Bulletin No. 2002-22

Mechanical Steer Foot Pedal (Tour Edition)

Figure 1

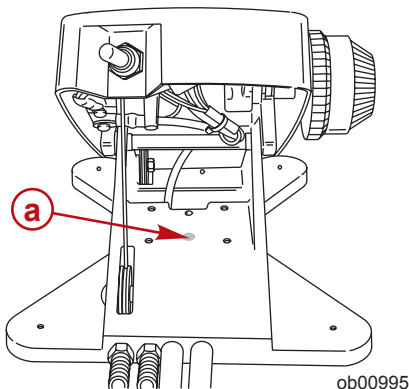
Tour Edition models that are within the affected serial number range should be inspected for a **white** dot as shown. The white dot indicates that the unit has been previously inspected.

A **white** paint dot must be applied to the foot pedal after completion of the rework as shown in Figure 1.

Figure 2

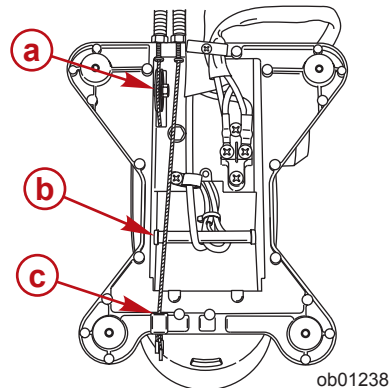
If the foot pedal assembly does not have the identifying mark, check the bottom side of the foot pedal. The e-clip securing the pivot pin should be located on the pulley side of the foot pedal. If the e-clip is located on the opposite side, the foot plate may contact the rear pulley which could cause the steering cable to slip off of it.

1. If the e-clip is located on the incorrect side, loosen the tension on the steering cables.
2. Remove the e-clip from the pivot pin and push the pin out.
3. Reinstall the pin ensuring that the e-clip end is on the same side as the steering pulleys.
4. Reinstall the e-clip on the pivot pin. Check to ensure that the steering cables are positioned on the pulleys and tighten the tension on the cables for proper operation. See Figure 2, preceding.
5. After the correction has been completed, apply a white paint dot to the foot pedal assembly.
